ADDENDUM TO THE CONTRACT DOCUMENTS

ADDENDUM NO. 002
	Project: Solano Community College District Building 1600 Modernization Project Project Number: 25-009
	Date: July 12, 2024

3 LOBBY RECEPTION DESK - FLOOR PLAN & ELEVATIONS
SCALE: 1/2" = 1'-0"

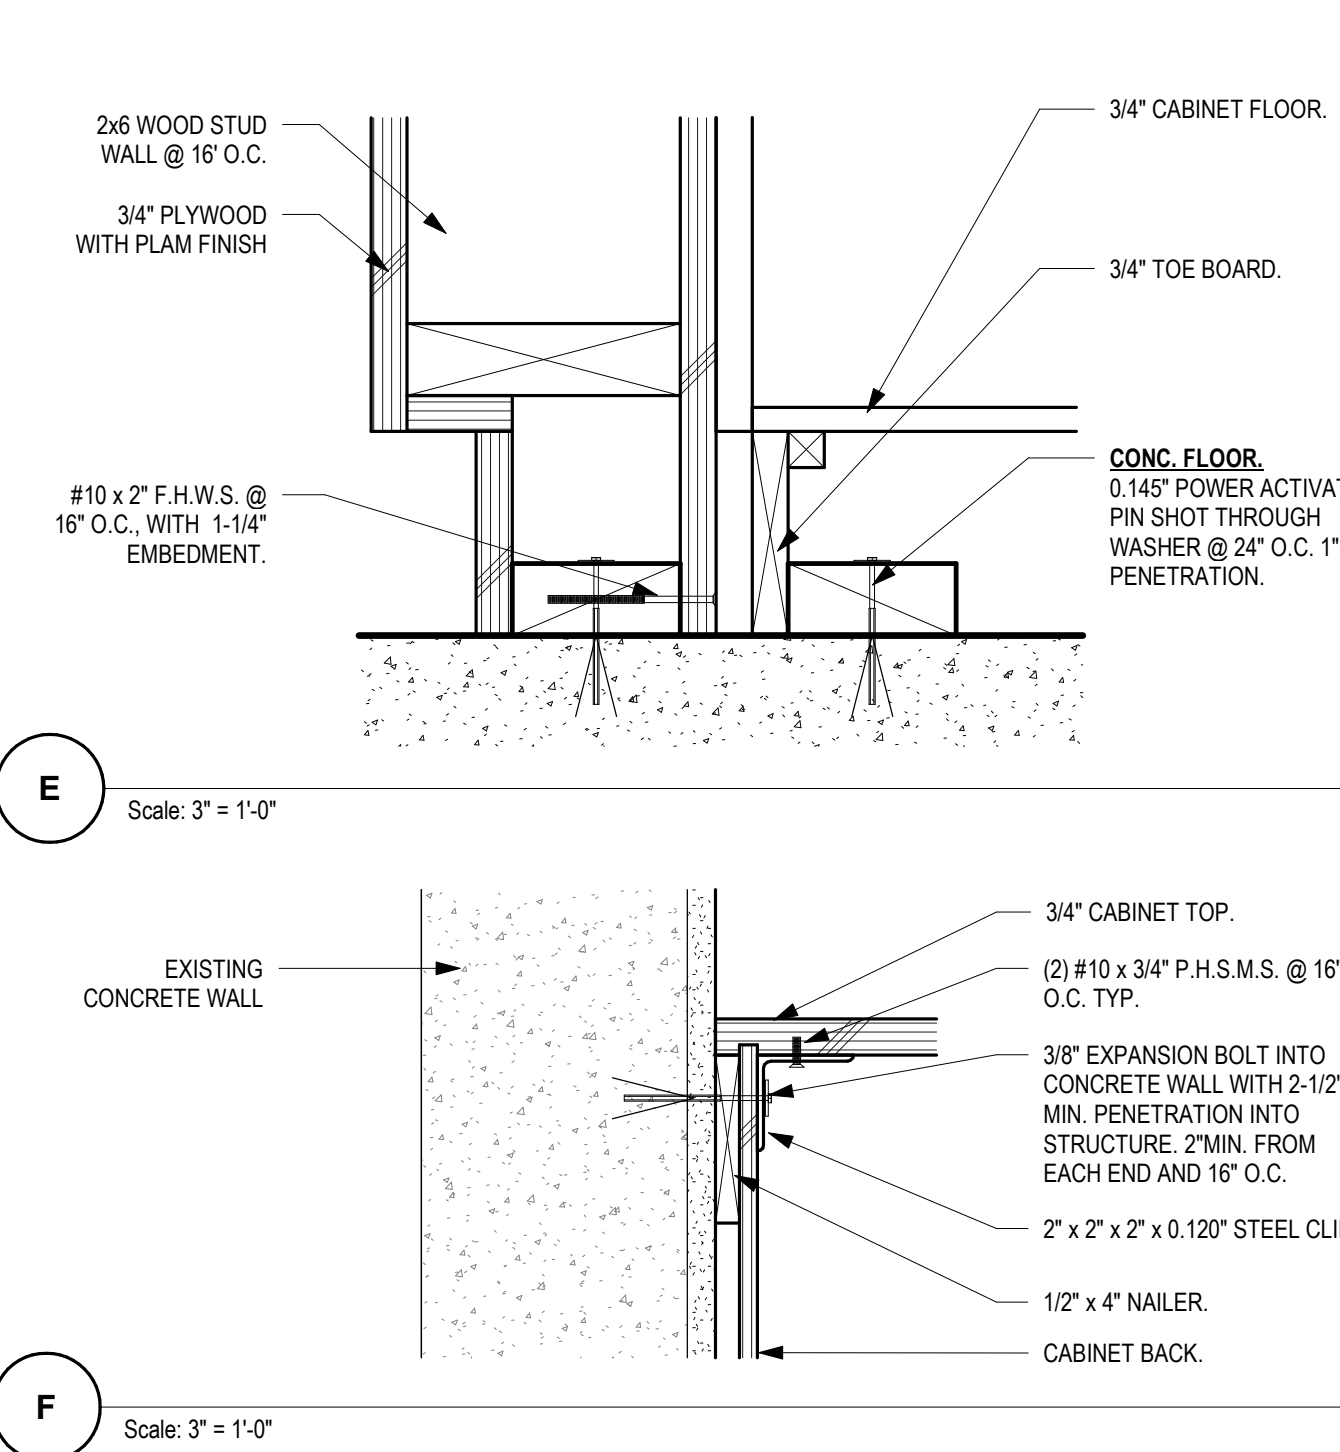
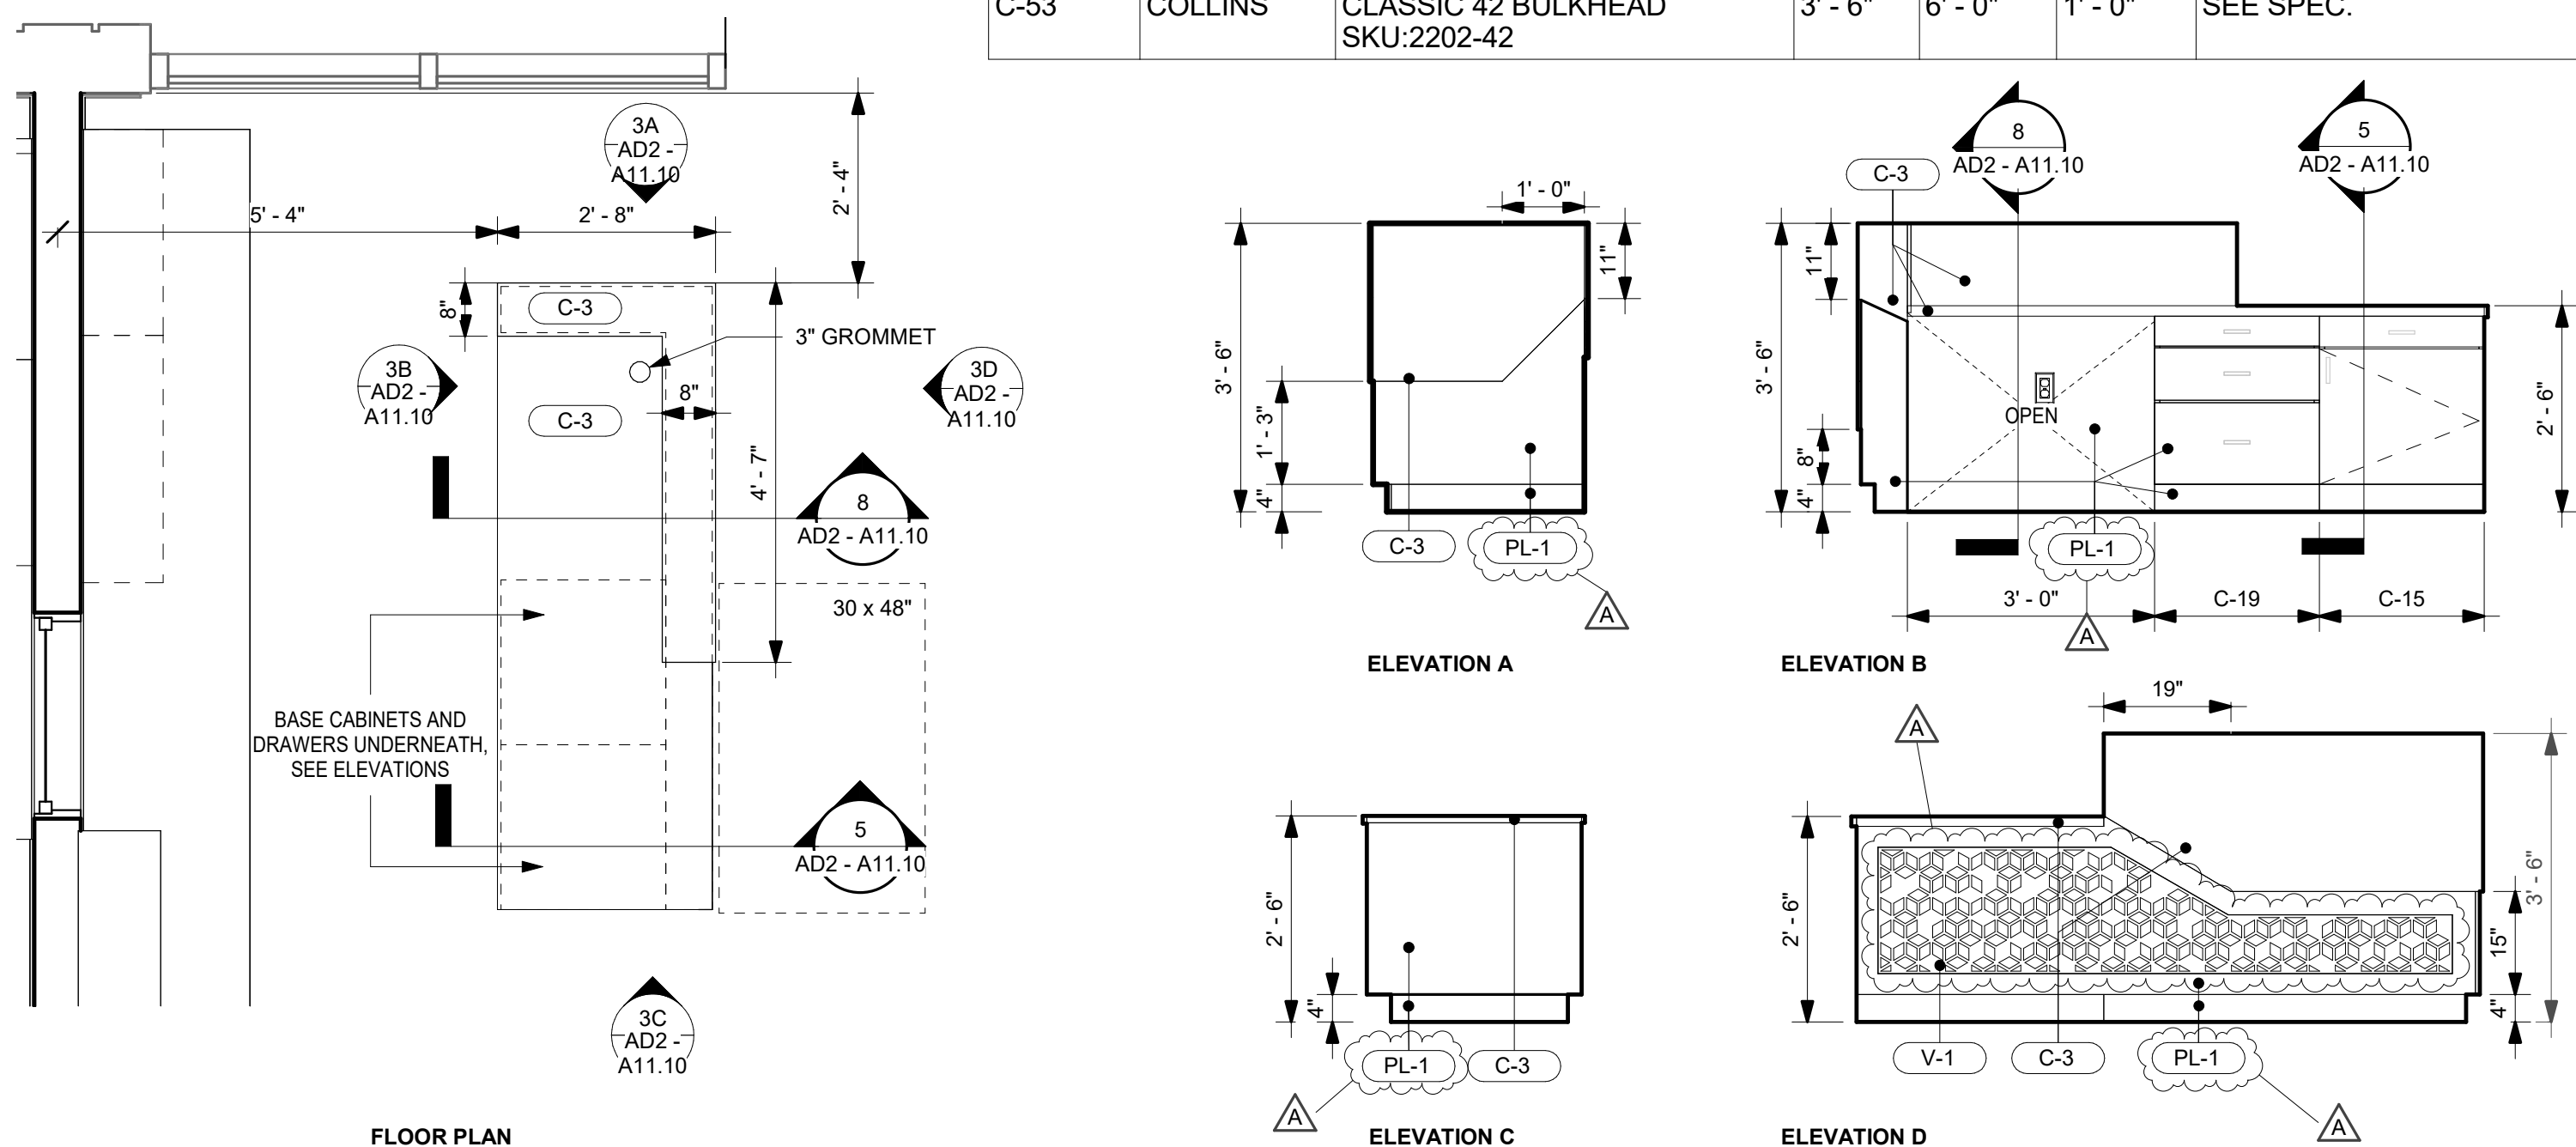
Revise: Finish Tags from "PL-3" to read:" PL-1" in Elevations 3 – "Lobby reception desk – floor plan & elevations – A, B, C and D" as shown in attached sheet AD2-A11.10

Add: Vinyl sheet pattern in Elevations 3 – "Lobby reception desk – floor plan & elevations – Elevation D" as shown in attached sheet AD2-A11.10

1 1611 - ESTHETICS
SCALE: 1/4" = 1'-0"

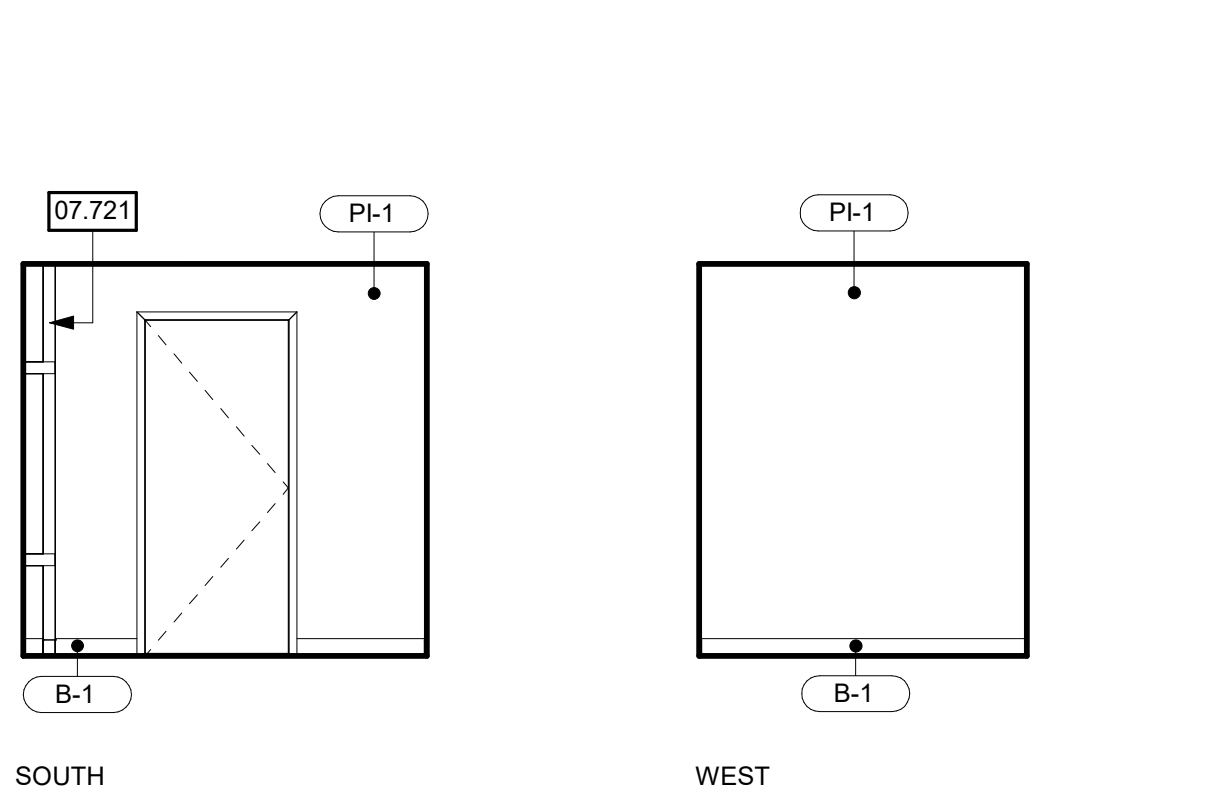
Revise: Casework Tags from "C-14a" to read:" C-11" in Elevations 1 – "1611 – Esthetics – North" as shown in attached sheet AD2-A12.03.

2 1625 - CLASSROOM
SCALE: 1/4" = 1'-0"

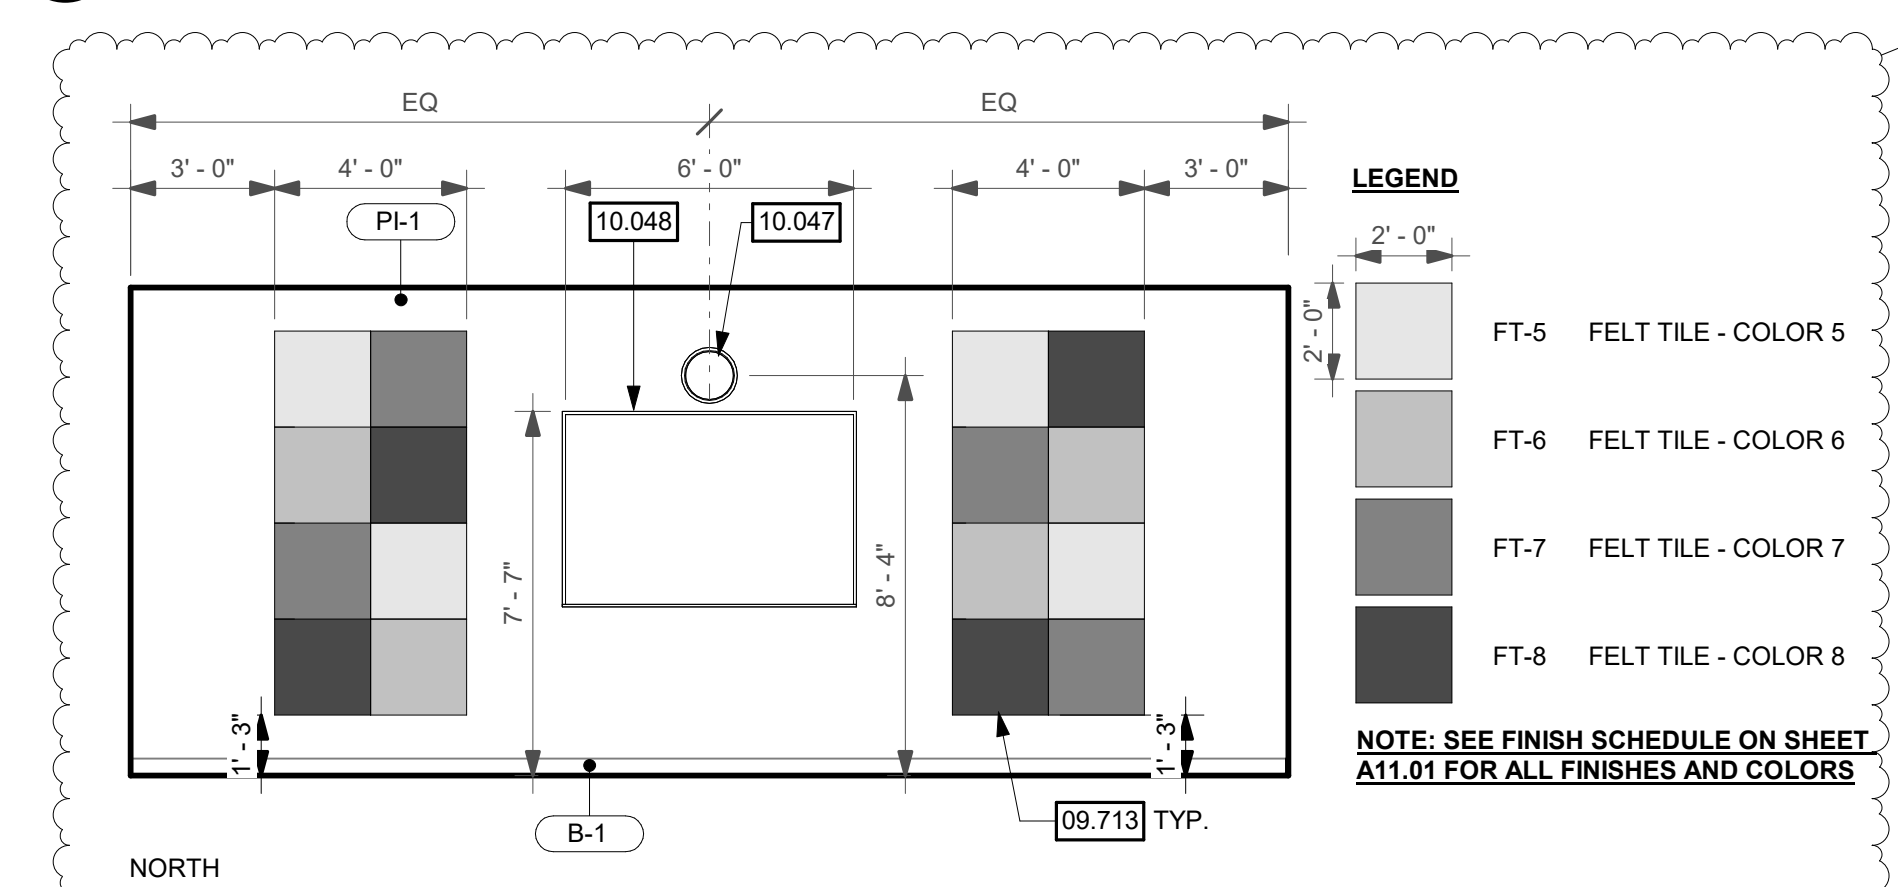
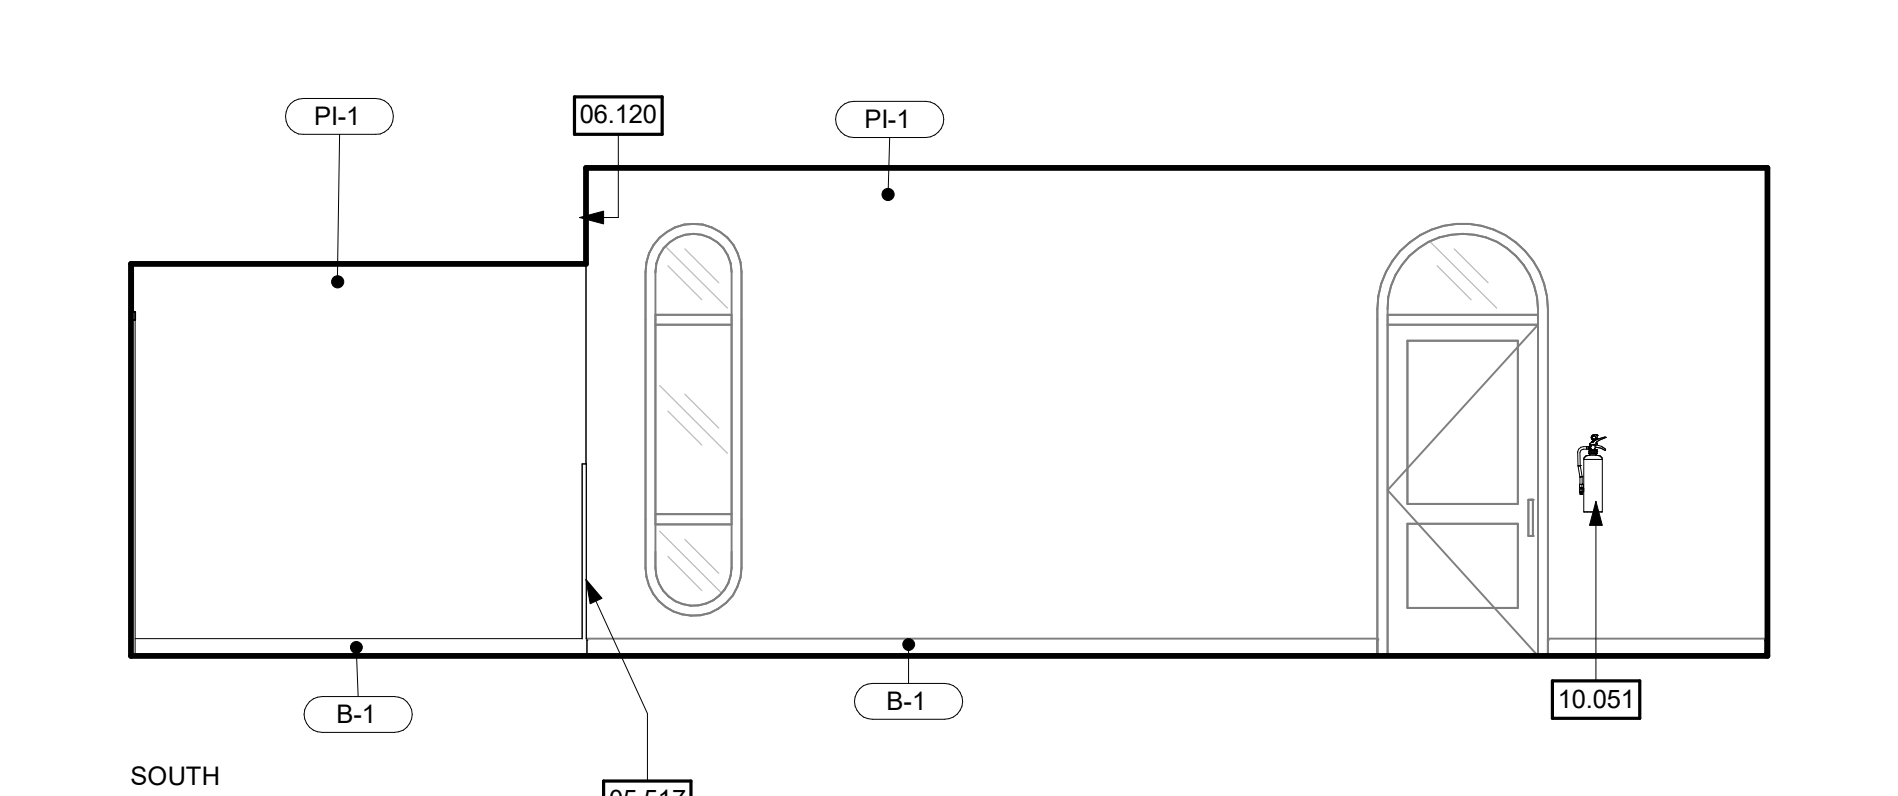
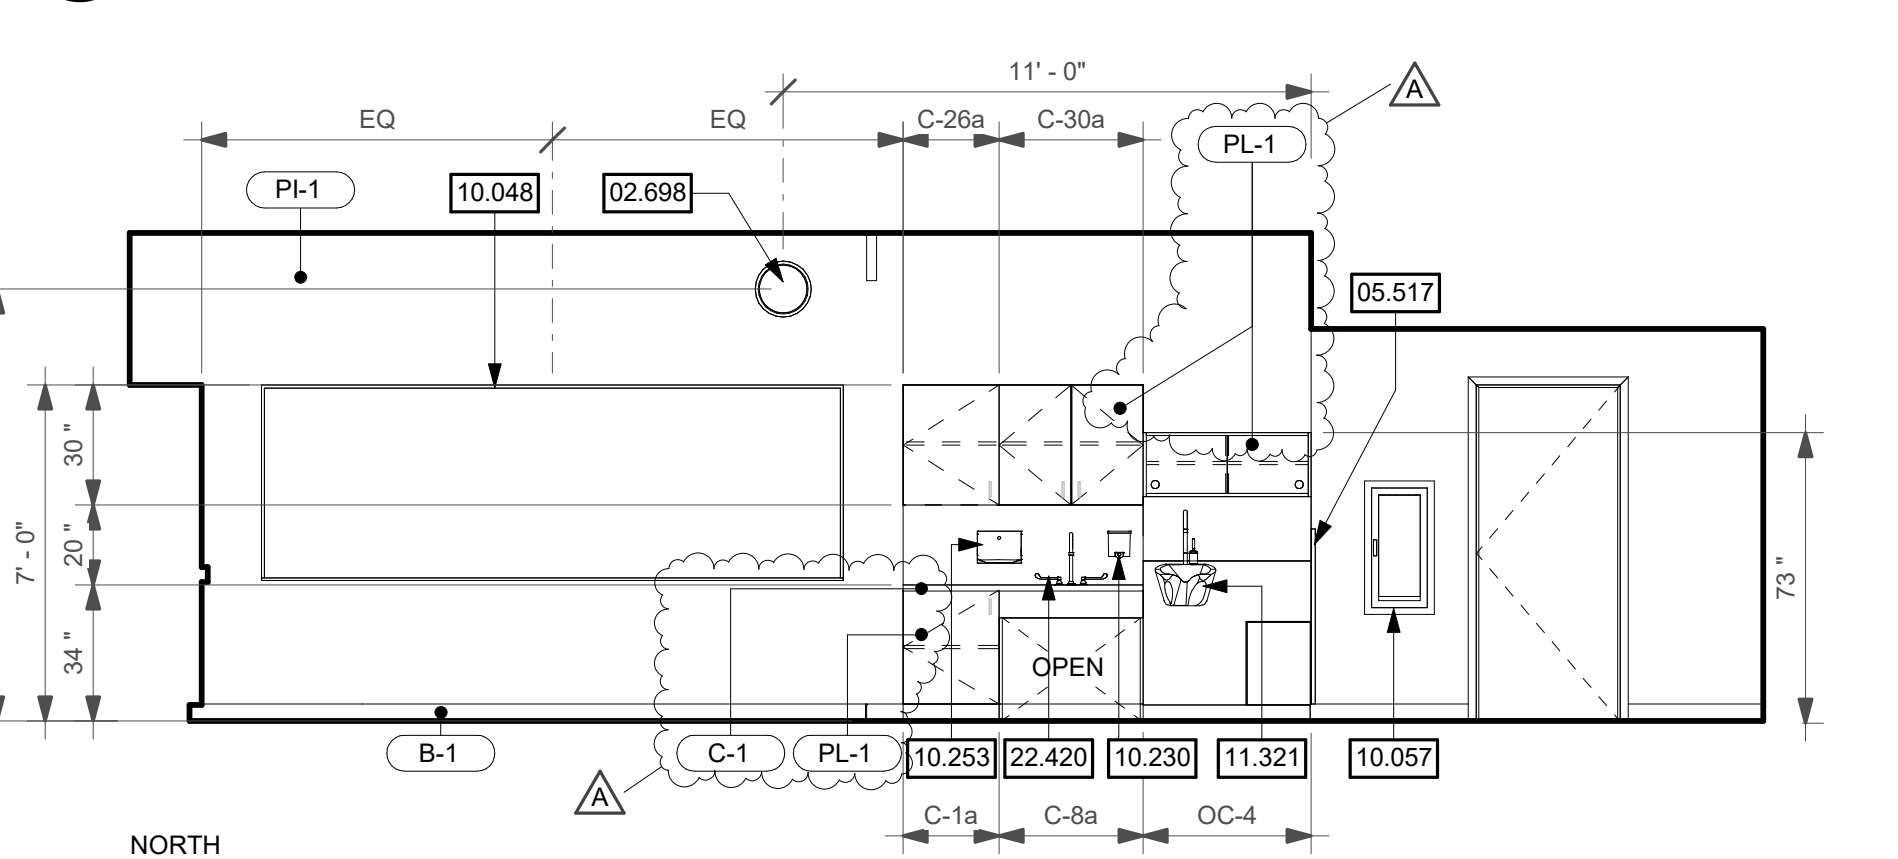
Add: Finish Tags as shown in attached sheet AD2-A12.03.
Revise: Elevations 2 – “1625 – Classroom – North” as shown on attached sheet AD2-A12.03
Revise: Finish legend PL-3 to read: “Plastic Laminate 3” as shown on attached sheet AD2-A12.03
Add: Finish legend PI-5 to read: “Interior paint accent 3” as shown on attached sheet AD2-A12.03
